REGULATION No. 48  
(Installation of lighting and light-signalling devices)

Clarifications on installation requirements

Proposal for draft Supplement 5 to the 03 series of amendments to Regulation No. 48

Submitted by the expert from Germany \*/

Figure 1

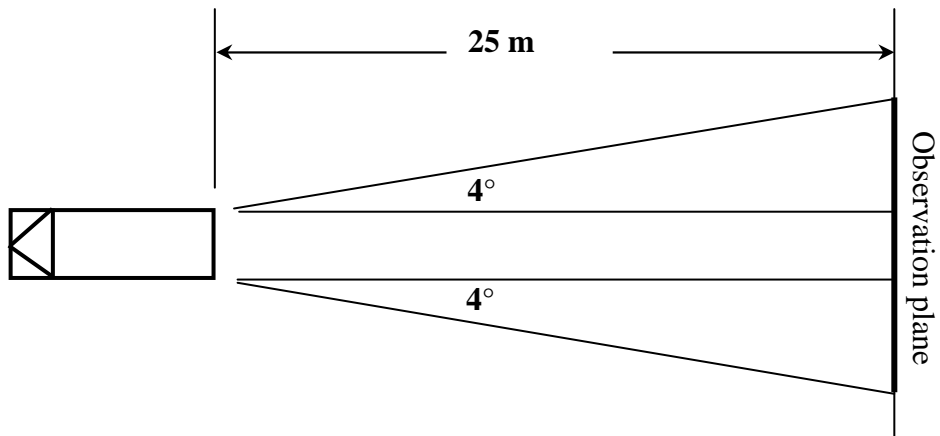
- 6.21.5.1. for rear conspicuity markings (see Annex 11, Figure 1) the observation plane is perpendicular to the longitudinal axis of the vehicle situated **25 m** from the

- 6.21.5.1.1. in height, by two horizontal planes 1 m and 3.0 m respectively above the ground,
- 6.21.5.1.2. in width, by two vertical planes which form an angle of 4° outwards from the vehicle's median longitudinal plane and which pass through the intersection of the vertical planes parallel to the vehicle's median longitudinal plane delimiting the vehicle's overall width, and the plane perpendicular to the longitudinal axis of the vehicle that delimits the end of the vehicle.

Figure 2

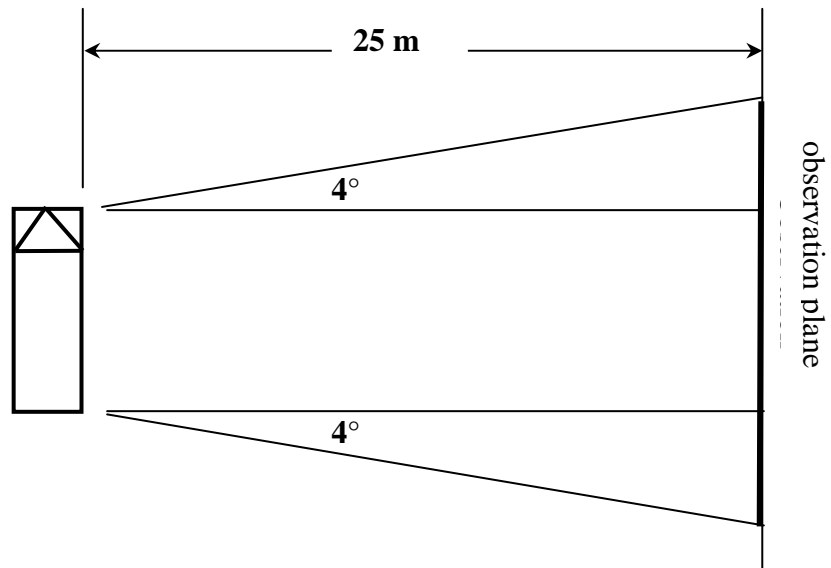
- 6.21.5.2. for side conspicuity markings (see Annex 11, figure 2) the observation plane is parallel to the longitudinal median plane of the vehicles situated **25 m** from the extreme outer edge of the vehicle and bounded by:

- 6.21.5.2.1. in height, by two horizontal planes **1.0 m** and **1.5 m** respectively above the ground,
  - 6.21.5.2.2. in width, by two vertical planes which form an angle of 4° outwards from a plane perpendicular to the vehicle's longitudinal axis and which pass through the intersection of the vertical planes perpendicular to the vehicle's longitudinal axis delimiting the vehicle's overall length and the extreme outer edge of the vehicle."
